RESOLUTION NO. 2010-06

**A RESOLUTION OF THE PLANNING COMMISSION OF THE CITY OF LEMOORE
APPROVING A ONE-YEAR EXTENSION FOR SITE PLAN REVIEW NO. 2007-09 / CONDITIONAL
USE PERMIT NO. 2008-02 / SPECIAL ZONING EXEMPTION NO. 2008-01
TO CONSTRUCT CANDLEWOOD SUITES (AN 83 ROOM THREE STORY HOTEL)
BY LEMOORE EQUITY PARTNERS**

Redlined Site Plan for Candlewood Suites

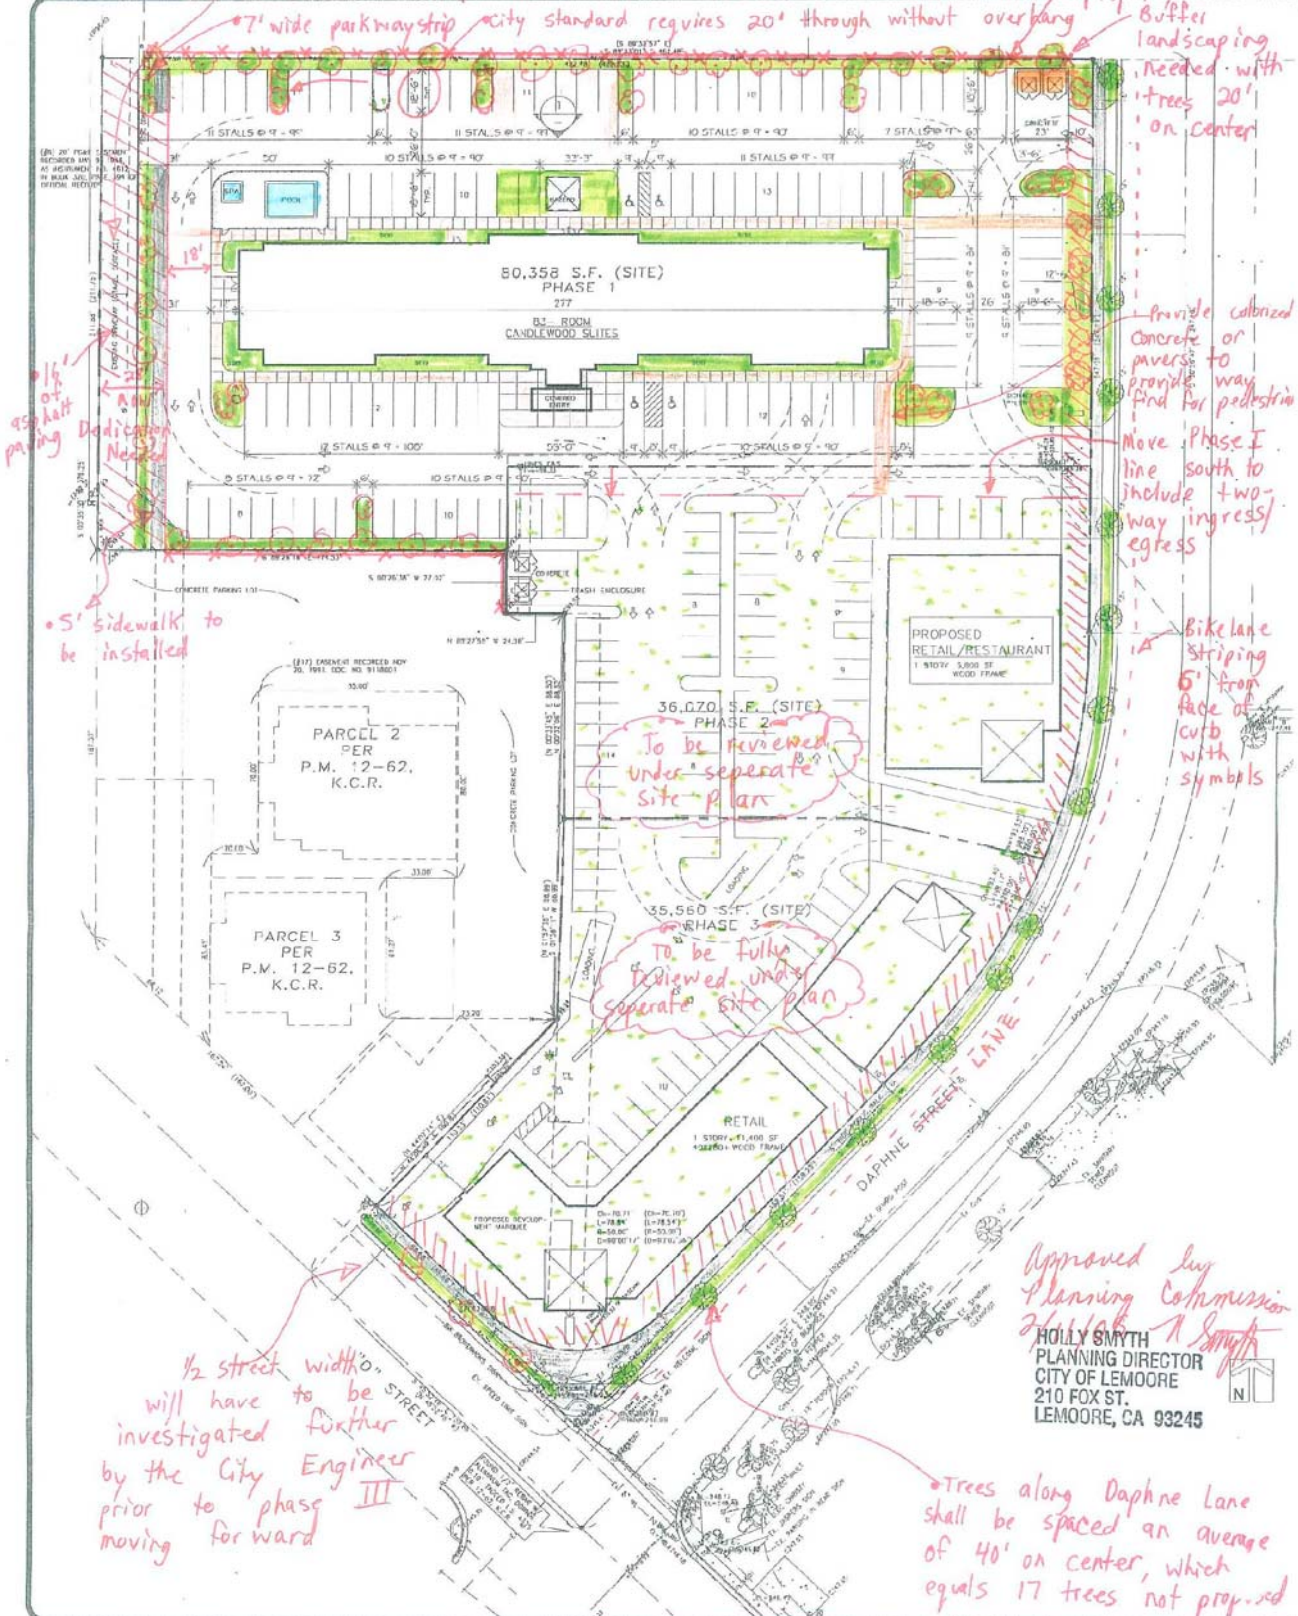
Drive access to be paved and maintain access to the north

6' wrought iron fence along north property line

7' wide parkway strip city standard requires 20' through without overhang

Buffer landscaping needed with trees 20' on center

provide colored concrete or pavers to provide way find for pedestrian

Move Phase I line south to include two-way ingress/egress

Bikeline Striping 6' from face of curb with symbols

To be reviewed under separate site plan

To be fully reviewed under separate site plan

5' sidewalk to be installed

1/2 of 45' halt paving

1/2 street width will have to be investigated further by the City Engineer prior to phase III moving forward

Trees along Daphne Lane shall be spaced an average of 40' on center, which equals 17 trees not proposed 15 trees.

- Public Utility Easement or street dedication to be offered
- Proposed landscape and additional City required landscape needed if Phase I
- Sidewalks needed with Phase I
- Colored concrete or pavers for pedestrian pathways (which will also be required to be incorporated into future phases)
- Wrought iron fence with vines
- Temporary landscaping needed
